Government of the District of Columbia

MEMORANDUM

SUBJECT: ZC Case No. 20-14 – 5 M Street SW

Figure 4 – Pedestrian Facilities (Source: CTR, Gorove/Slade, Figure 37, 8/17/20)

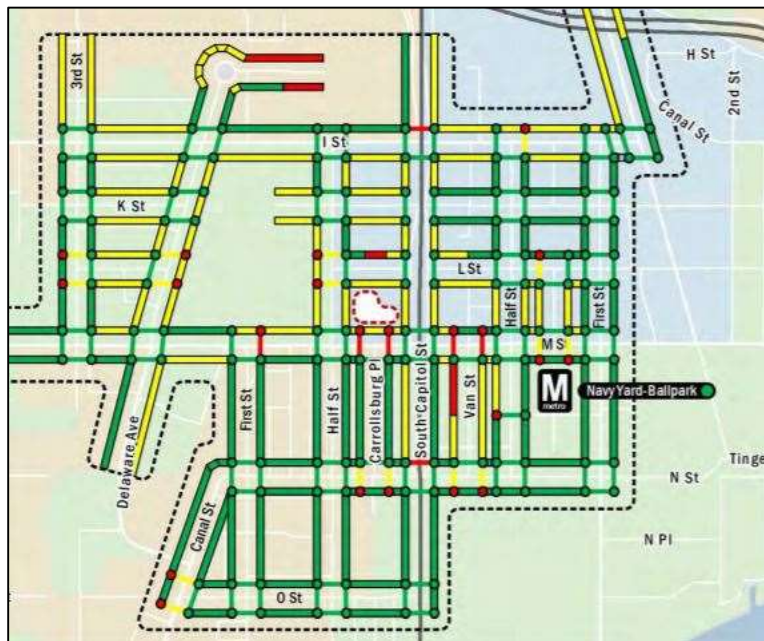
The site is well connected to transit hubs and neighborhood amenities via the sidewalk network. The area surrounding the site currently includes many substandard sidewalks and missing curb ramps and crosswalks. As part of this project, the Applicant will upgrade the sidewalk on all four sides of the block to meet current DDOT standards. There is one short segment of missing sidewalk on the north side of L Street. To improve pedestrian safety in the vicinity of the site and to encourage more walking, DDOT requests the Applicant construct this missing segment of sidewalk and construct bulb-outs (design to be determined during permitting) at the three Half Street and L Street intersections surrounding the site. During permitting, DDOT will work with the Applicant to deploy additional high-visibility crosswalks where missing or faded.
